# TECHNICAL MEMORANDUM LOWER AQUIFER INVESTIGATION REPORT

AMERICAN CHEMICAL SERVICE, INC.  
NPL SITE  
GRIFFITH, INDIANA

Response to: Approval of the Lower Aquifer Technical  
Memorandum with Modifications;  
American Chemical Service, Inc.,  
NPL Superfund Site, Griffith, Indiana

**U.S. EPA Required Modifications to  
Lower Aquifer Investigation Technical Memorandum  
(dated September 1996) for American Chemical Services, Inc.,  
NPL Superfund Site, Griffith, Indiana**

**Table 14**  
**Lower Aquifer Monitoring Plan**  
**American Chemical Service, Inc. NPL Site**  
**Griffith, Indiana**

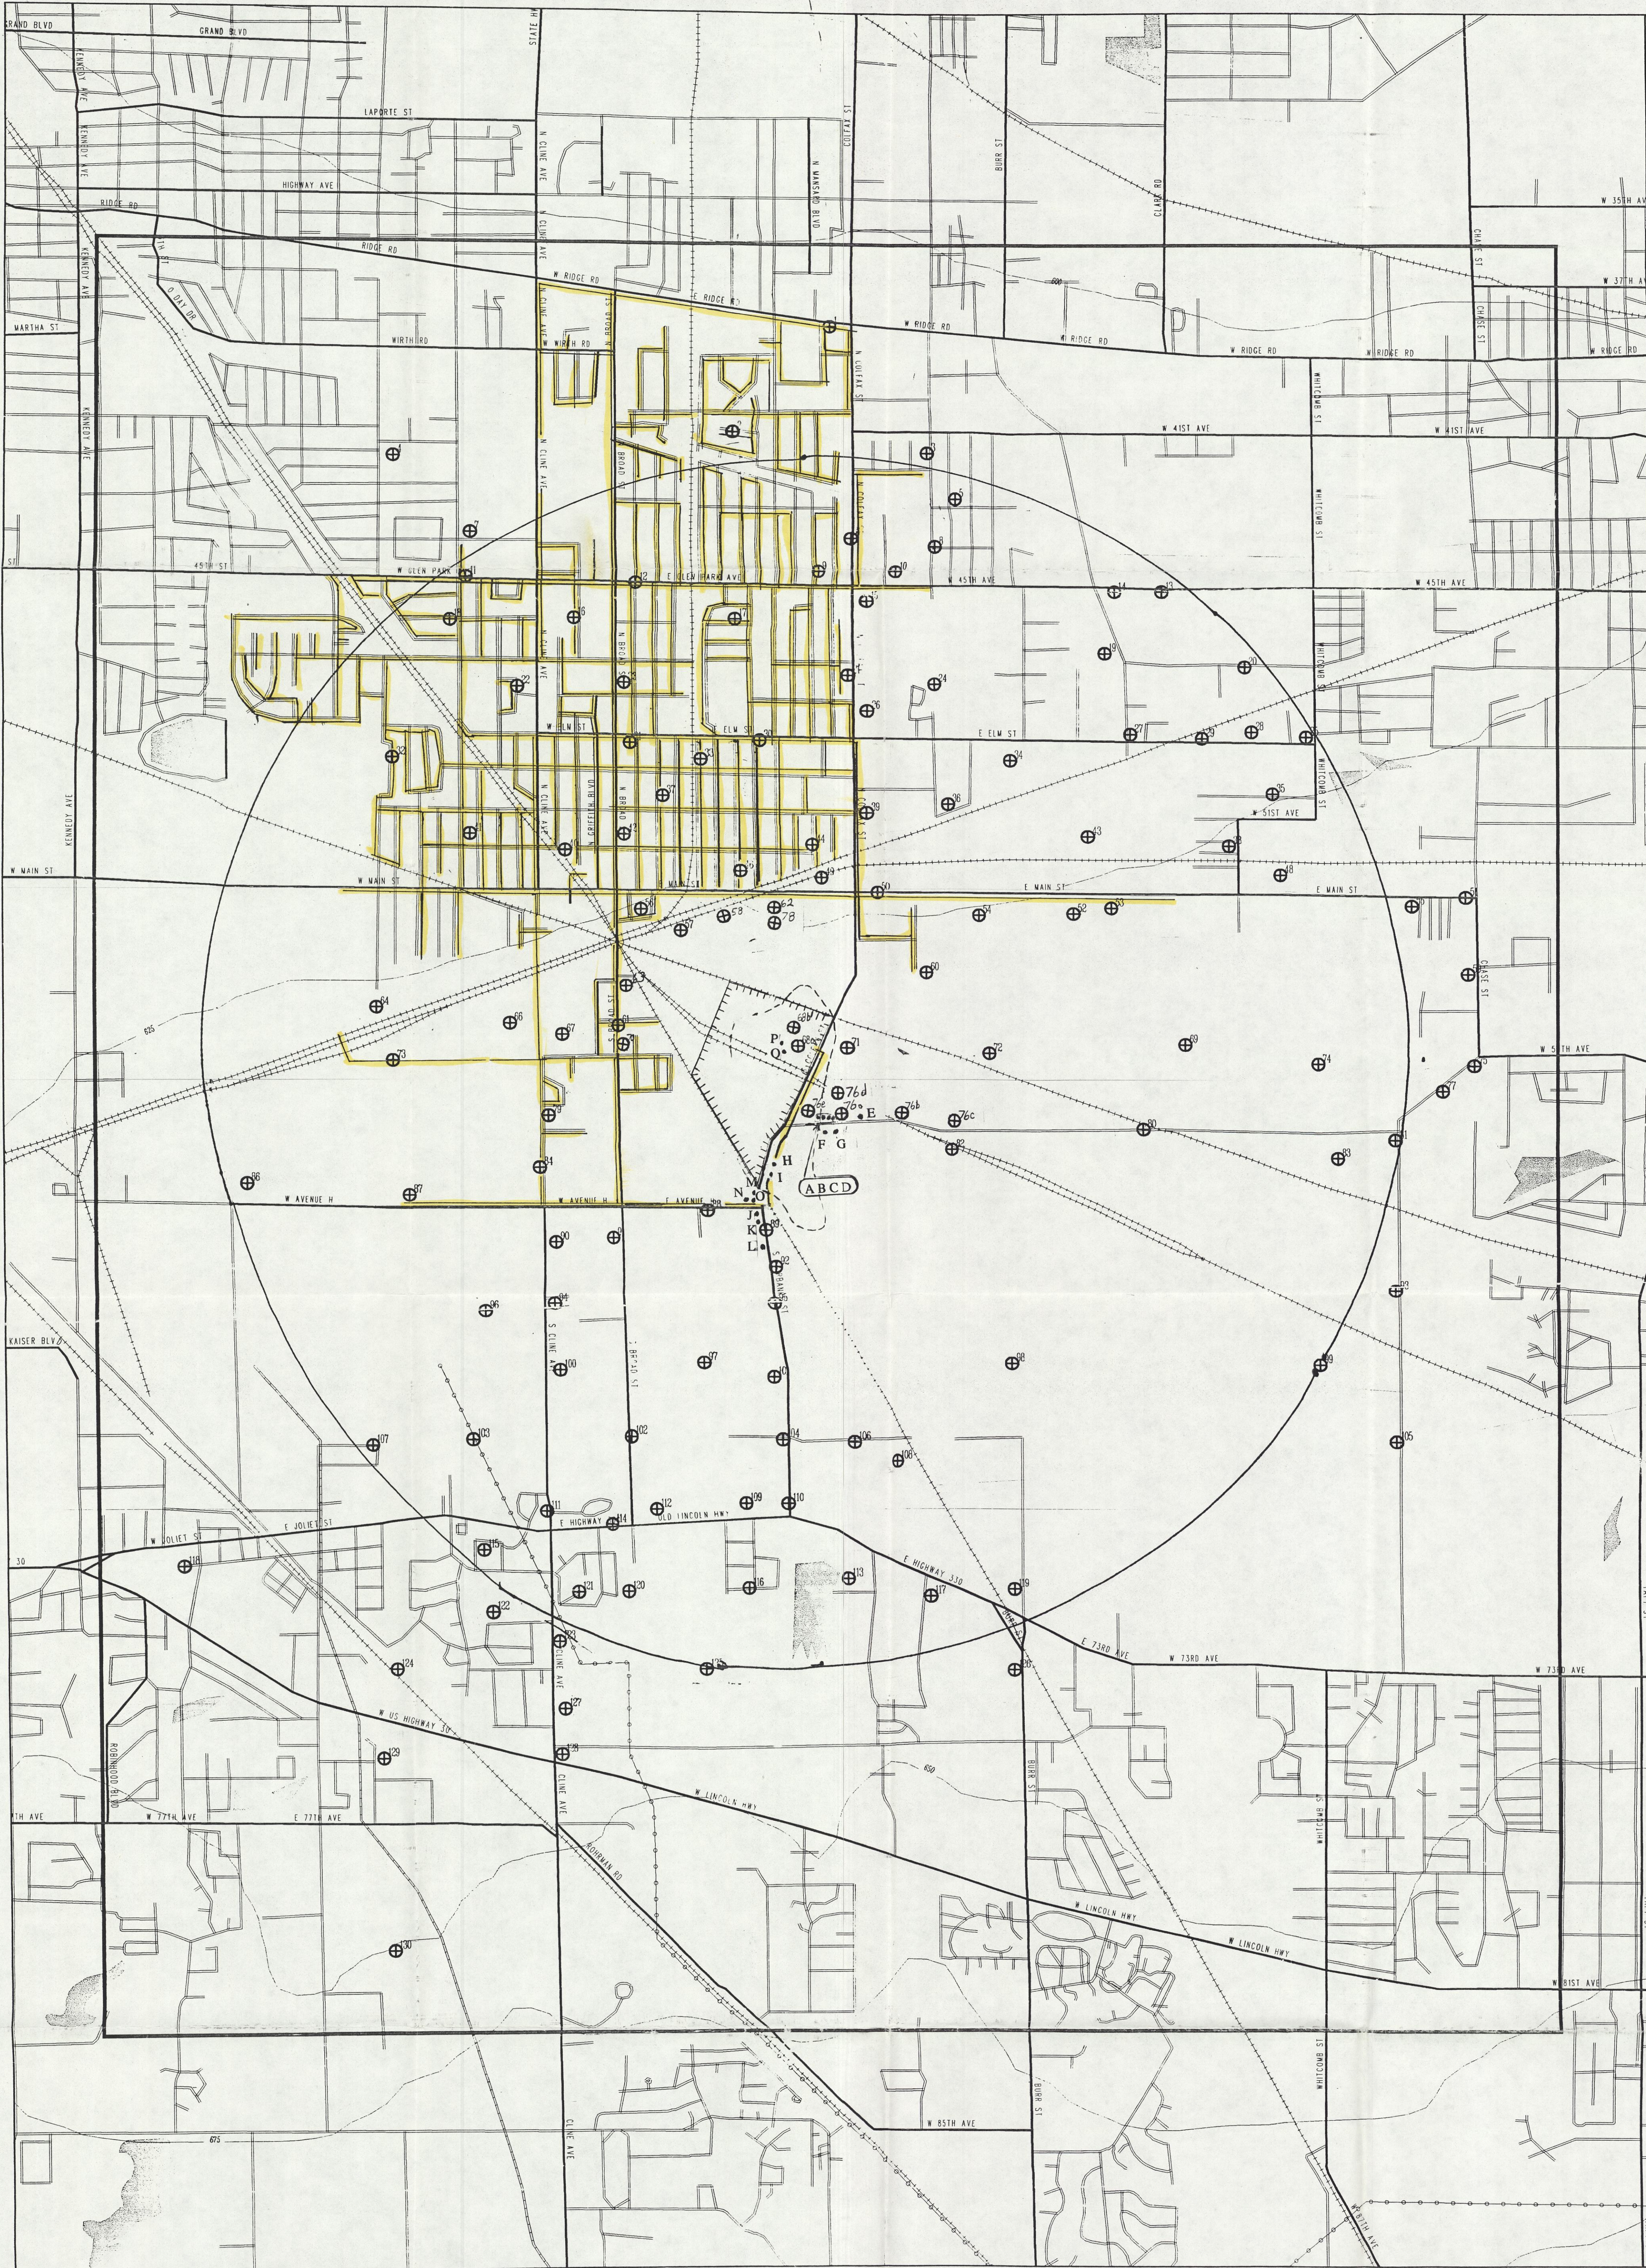
Include the newly installed well at the MW-10 location, (i.e., MW-50), discussed in Section 7.2.1, in the 4th quarter monitoring plan sampling.

**Monitoring well MW-51 (not MW-50) was installed as a replacement for monitoring well MW-10. A discussion of this installation has been added to Section 7.2.1. It is also included as well number 4 in Table 14.**
